Addendum #001

April 21, 2026

New Jetson Center for Youth
Baker, Louisiana
Project # 08-403-04-02, F.08000078, 08-403-24-01, F.08000165

1 SITE ELECTRICAL GROUNDING PLAN
1" = 40'-0" (For 30"x42" Sheet)

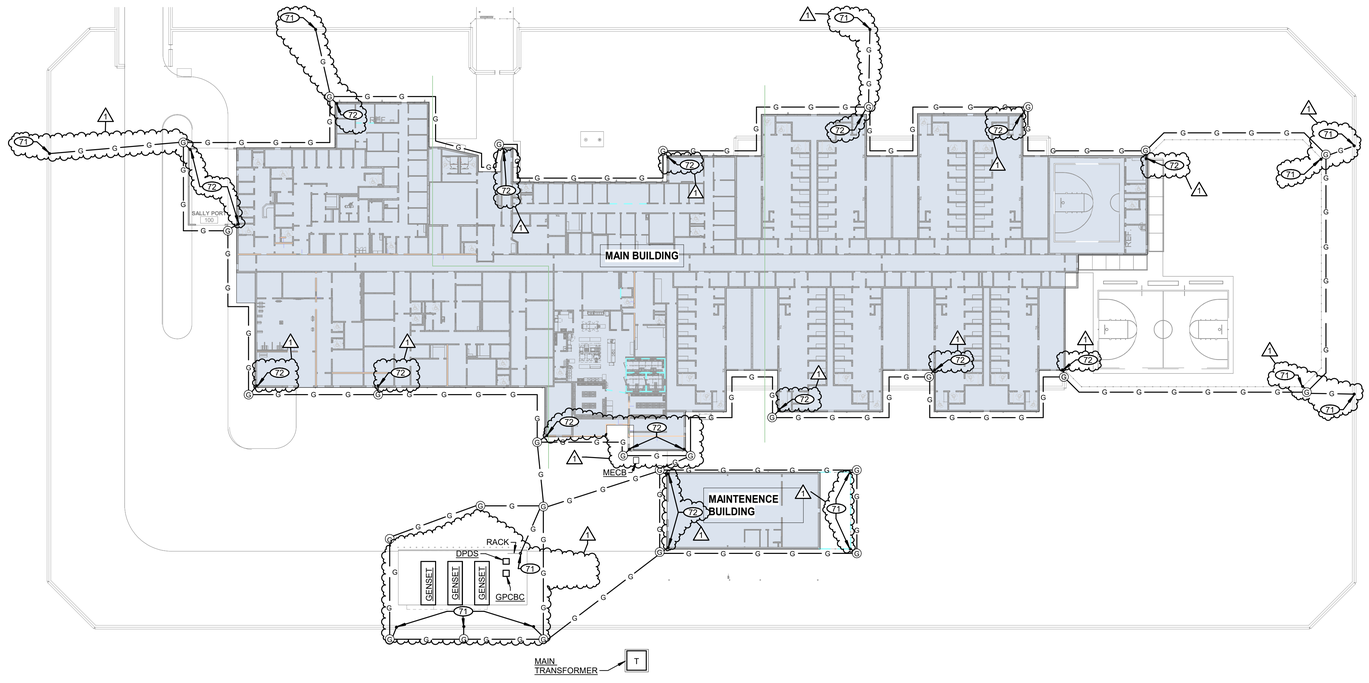
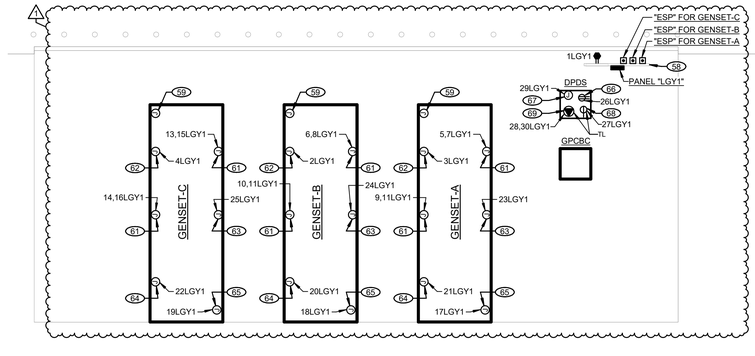
10. **RFI Question**: Electrical. Please confirm that Electrical Contractor is not responsible for Fence & Gate grounding.

a. Make changes to the “Site Electrical Grounding Plan” as shown
    b. Make changes to the “Generator Yard Electrical Plan” as shown.
3. **SHEET E100 – ELECTRICAL FLOOR PLAN - OVERALL**

Response: Ground the project fencing (and building steel) to the project underground ground ring. See Revised Electrical Drawing Sheet ES102, and see Added Referenced Electrical Notes Nos. 71 and 72, which are all parts of this project addendum.

1 ELECTRICAL FLOOR PLAN - OVERALL
3/64" = 1'-0" (For 30"x42" Sheet)

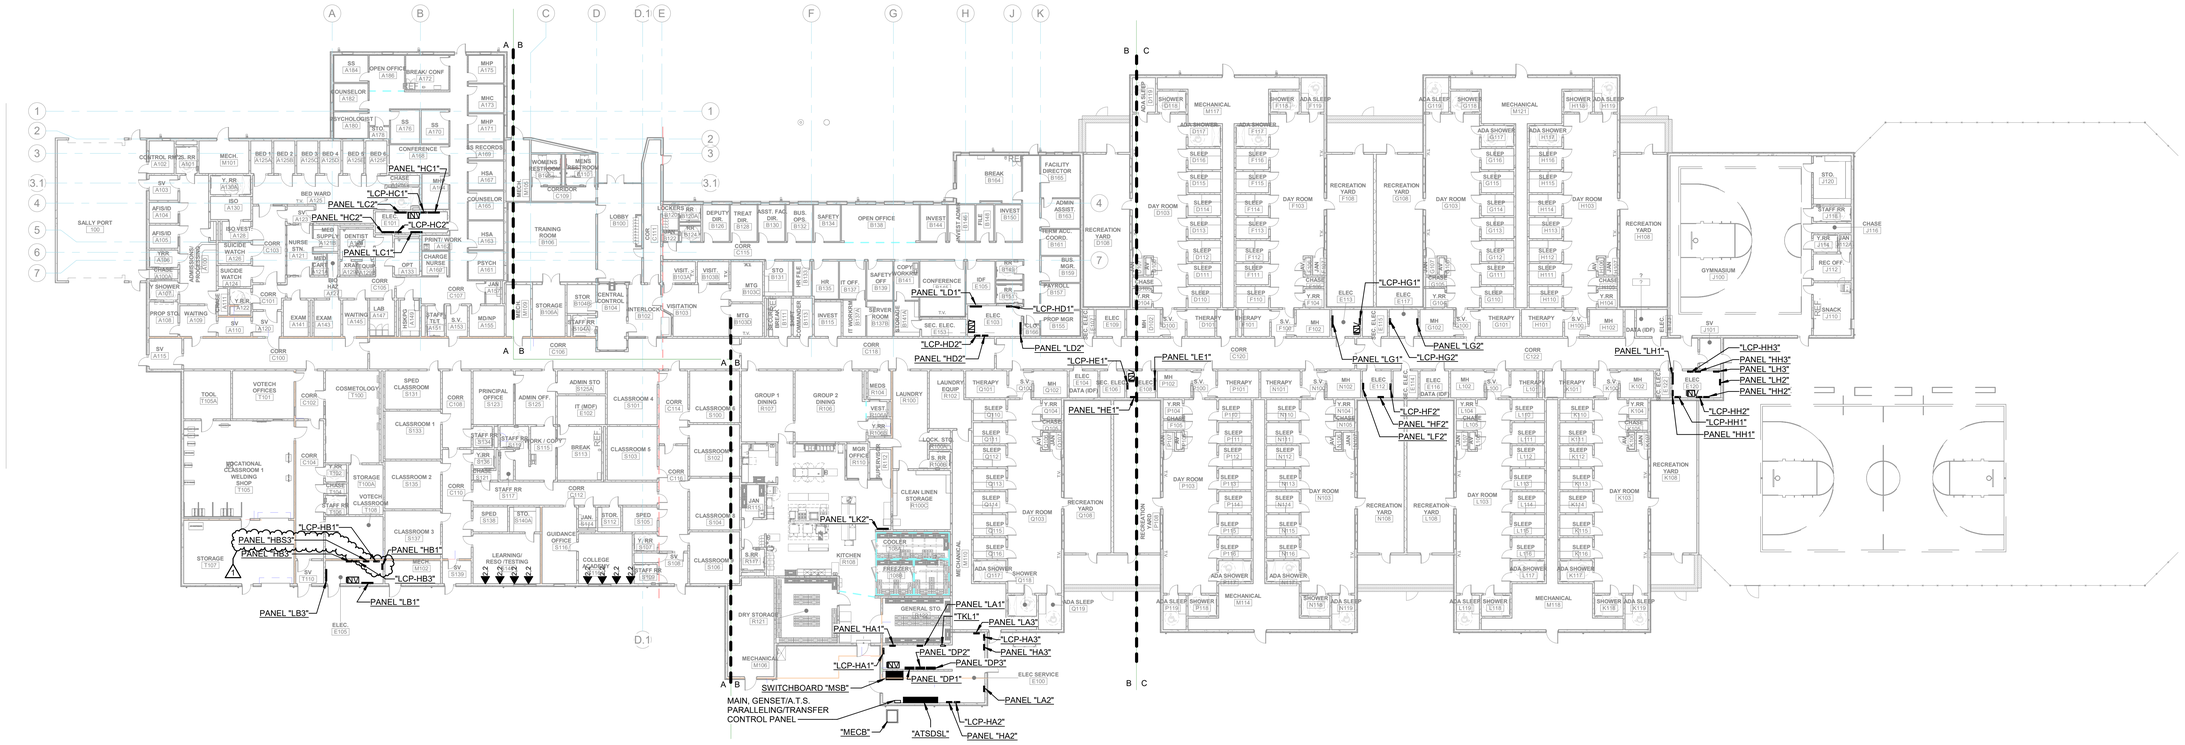
a. Make changes to the “Electrical Floor Plan - Overall” as shown
4. **SHEET E101a – ELECTRICAL LIGHTING PLAN – SECTOR A & LIGHTING CONTROL SEQUENCE OF OPERATIONS**

1 ROOF ELECTRICAL PLAN
3/32" = 1'-0" (For 30"x42" Sheet)

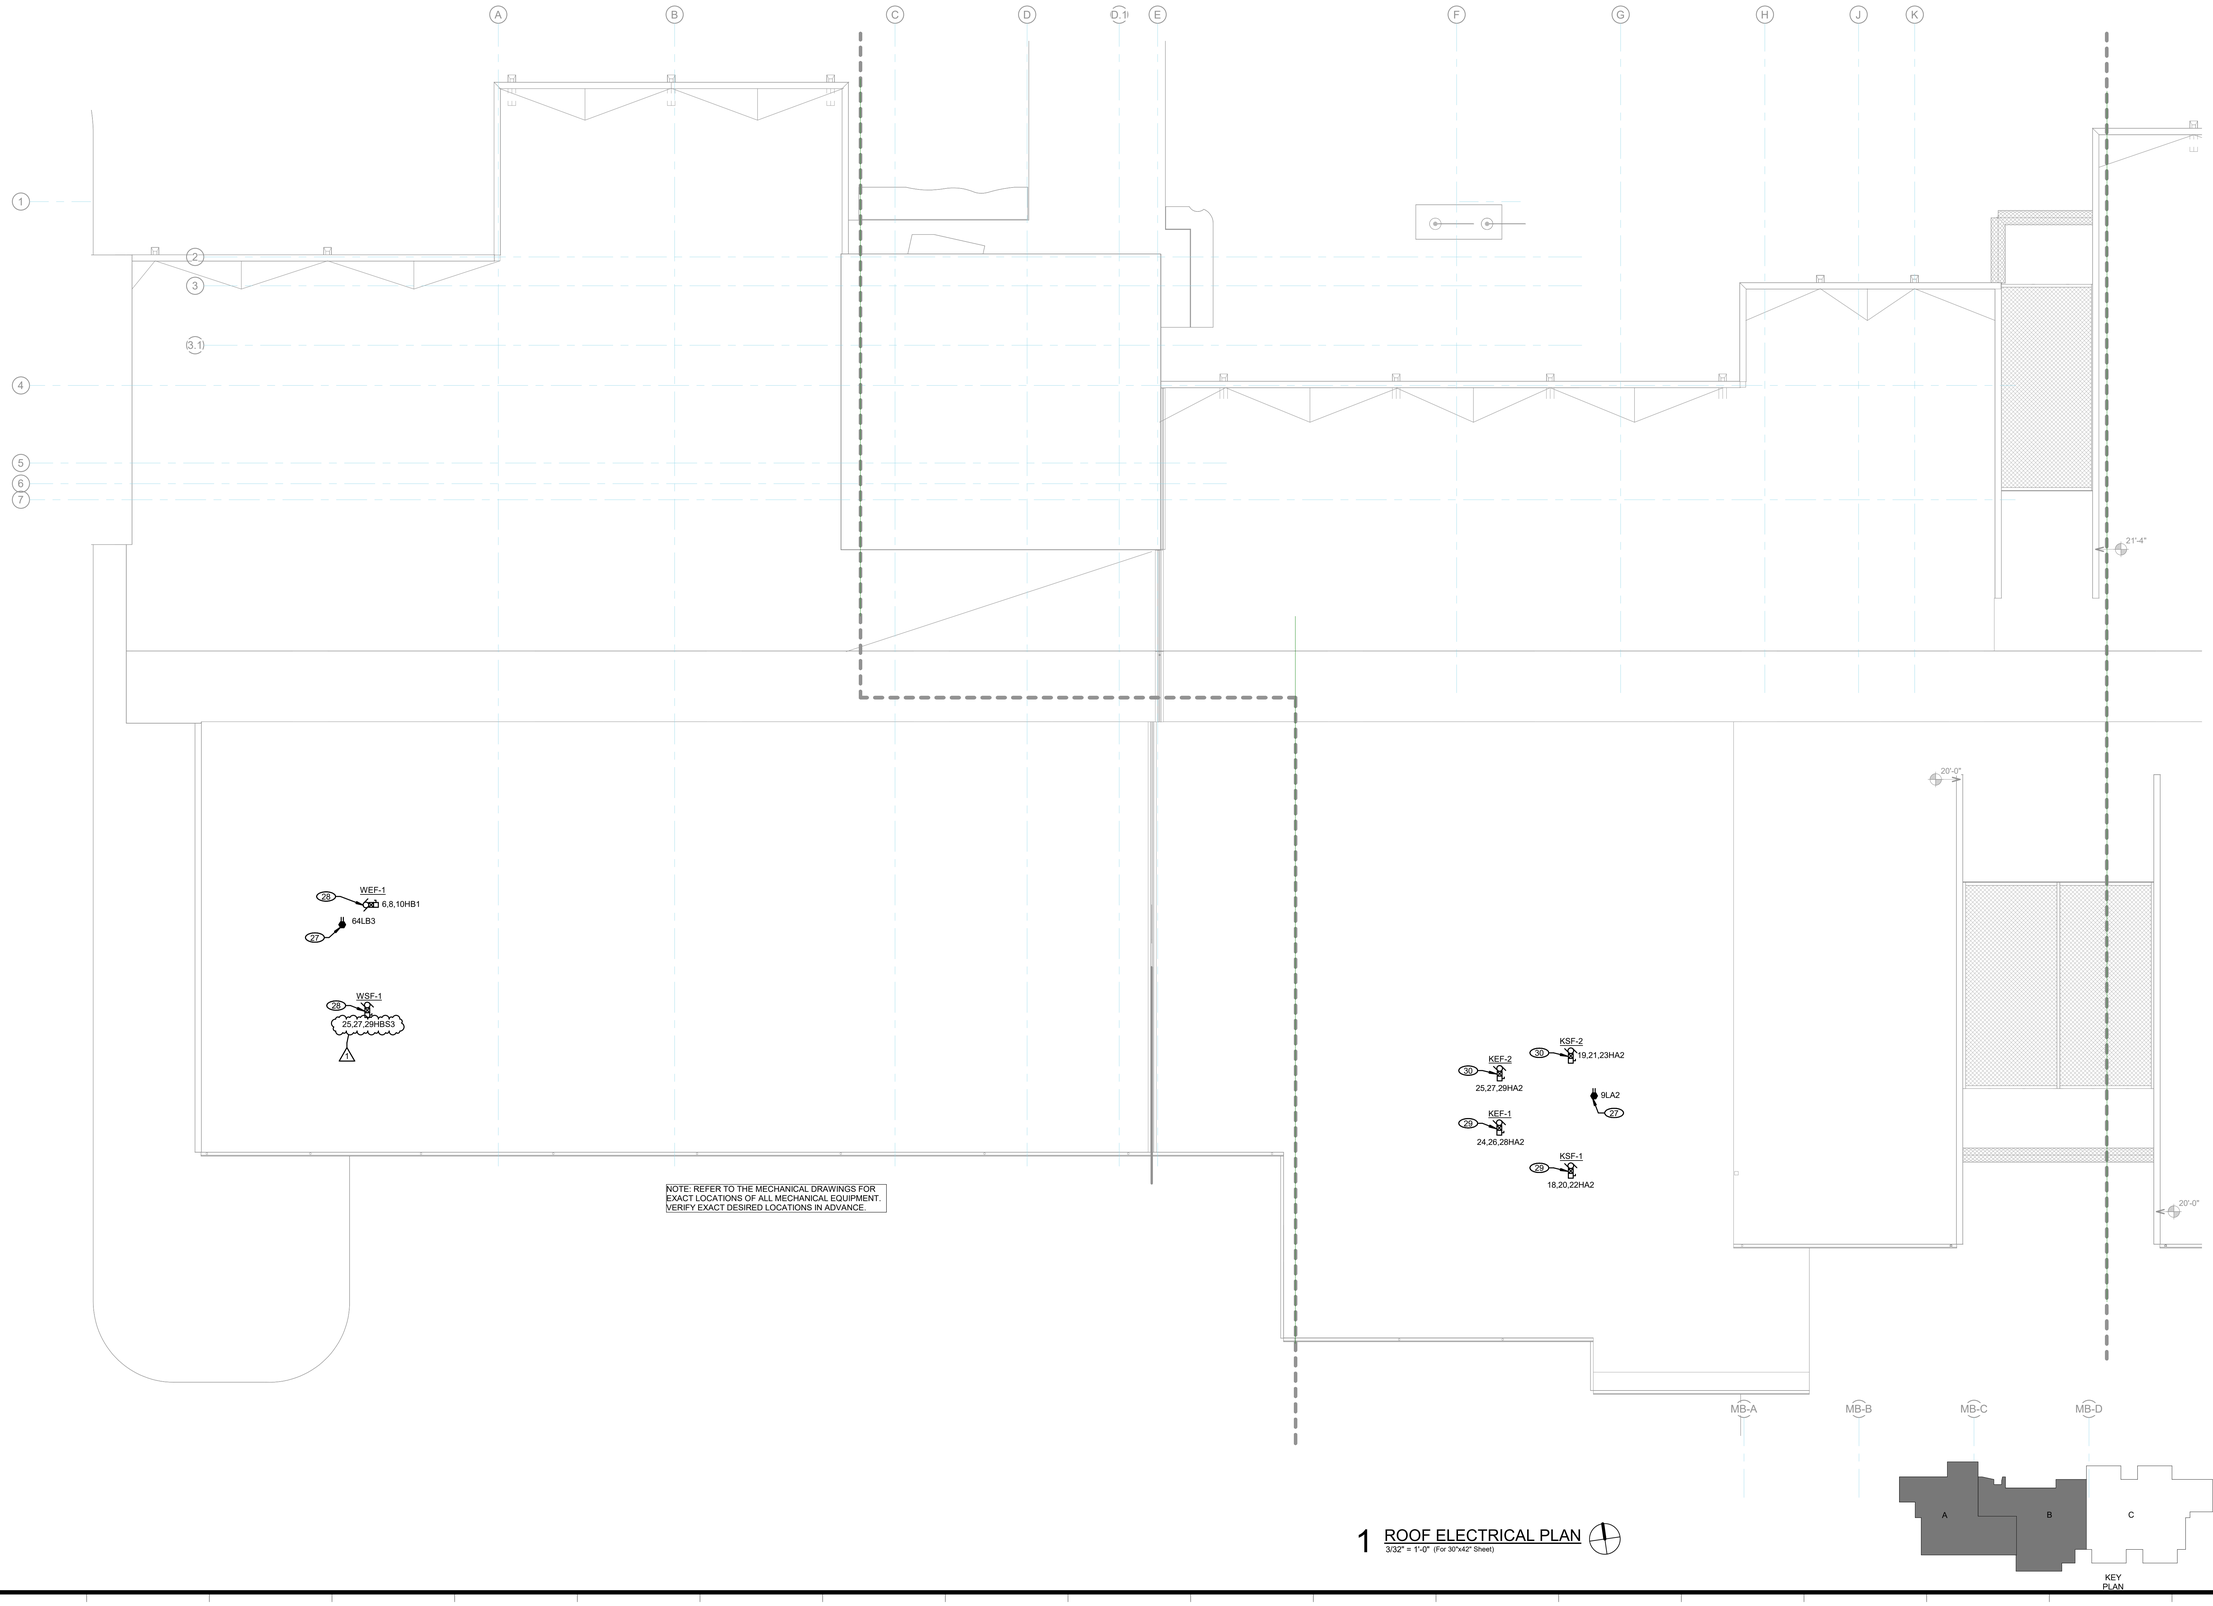
a. Make changes to the "Electrical Special Systems & Mechanical Electrical Connections Plan - Sector C" as shown.
14. **SHEET E401 – ROOF ELECTRICAL PLAN**

a. Make changes to the "Roof Electrical Plan" as shown.
15. **SHEET E501 – ELECTRICAL SYMBOL & ABBREVIATION SCHEDULE**
    a. Note changes to the "Electrical Symbol & Abbreviation Schedule" as shown.

4 EMERGENCY ENGINE-GENERATOR SET CONCRETE FOUNDATION DETAIL
N.T.S. (For 30"x42" Sheet)

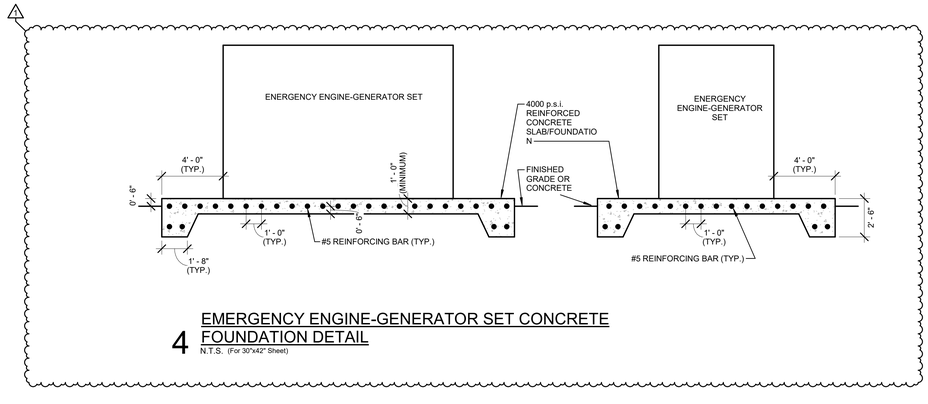
23. **SHEET E601 – ELCTRICAL DETAILS & WIRING DIAGRAM**
    a. Note addition of the "Emergency Engine-Generator Set Concrete Foundation Detail" as shown.

1 ELECTRICAL RISER DIAGRAM

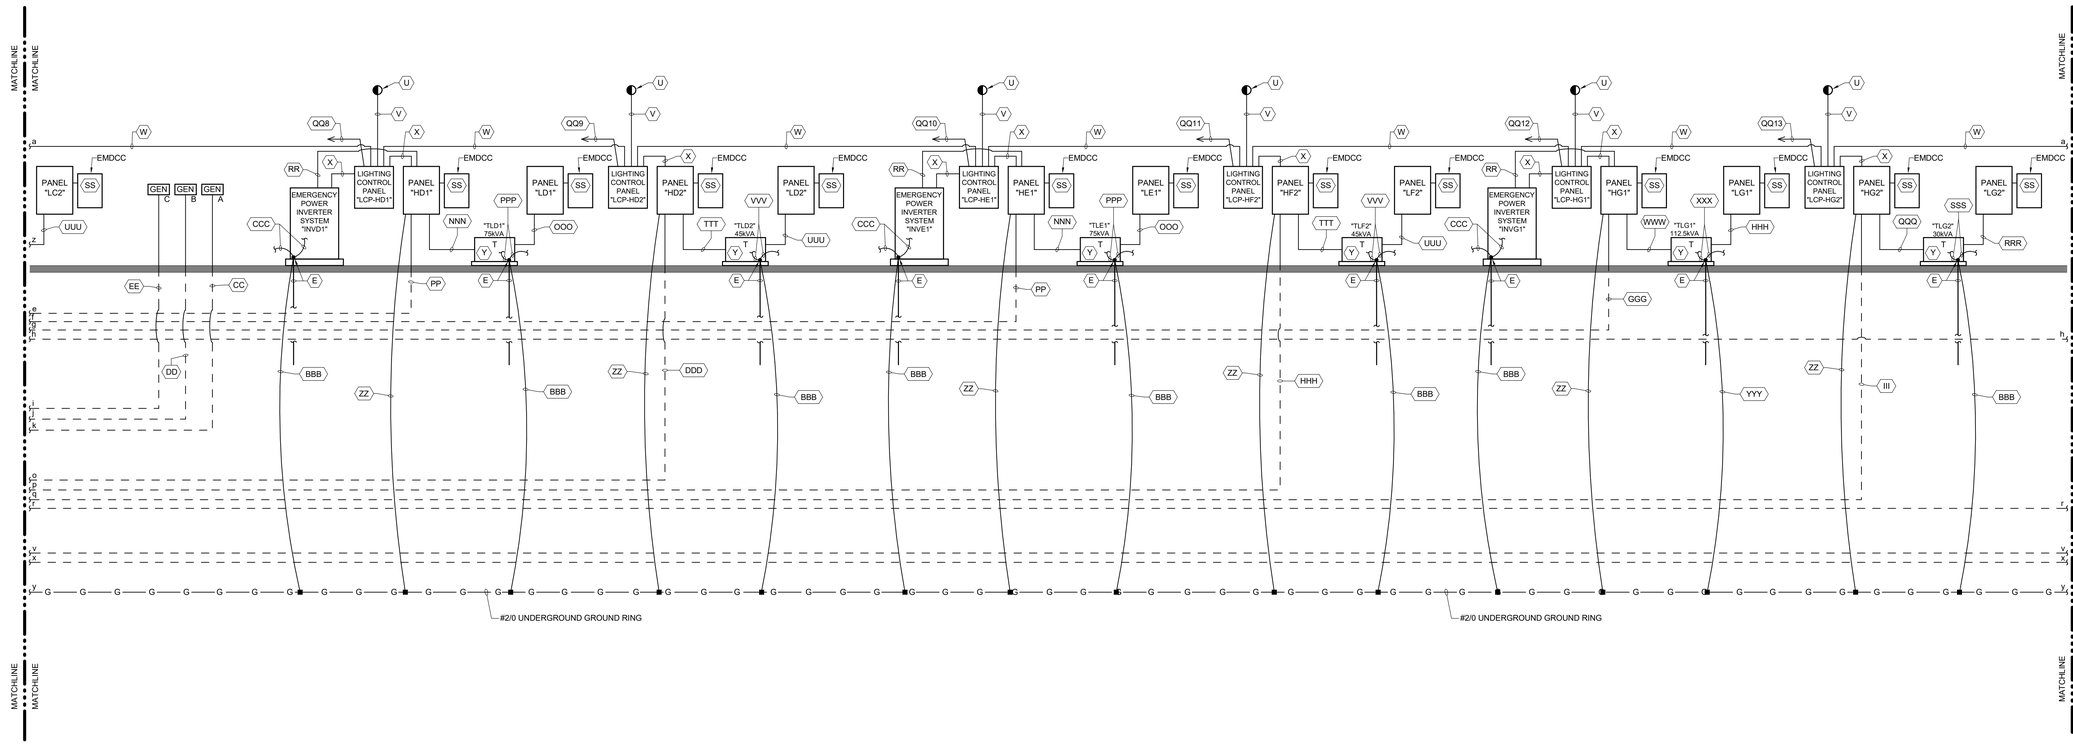
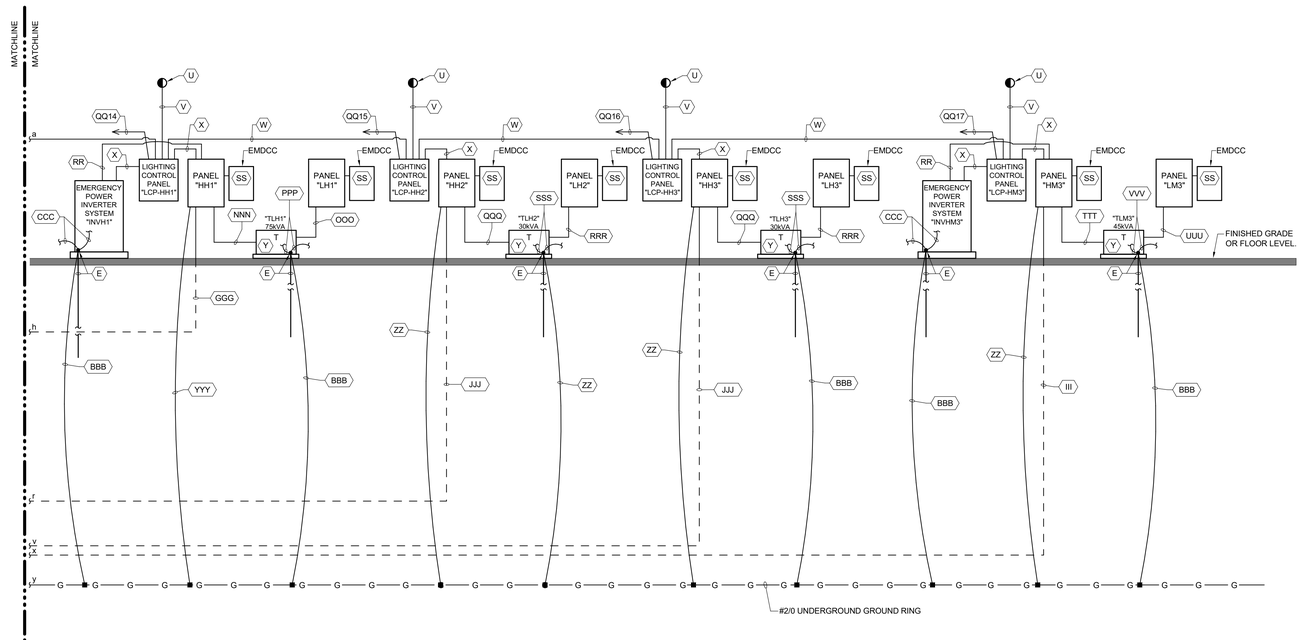
16. **RFI Question:** Electrical. Please confirm if GPCBC listed in the specifications is the same piece of equipment as GPCSL shown on E603.

17. **RFI Question**: Electrical. Please advise if GPCSL/GPCBC can be constructed as a switchboard rather than a switchgear as mentioned in Note O on E603.

18. **RFI Question**: Electrical. Please advise if ATSDSL can be constructed as a switchboard rather than switchgear as mentioned in Note Q on E603.

Response: Yes, they are the same piece of equipment. The "GPCSL" typographical error on Sheet E603 is being corrected to "GPCBC" as part of this addendum.

Response: GPCBC shall be a generator-paralleling, common-bus, connection cabinet; therefore, if should not be either a switchboard or switchgear.

Response: ATSDSL may be of switchboard construction or switchgear construction, as long as all other specified and required characteristics, features, options, etc. are provided.
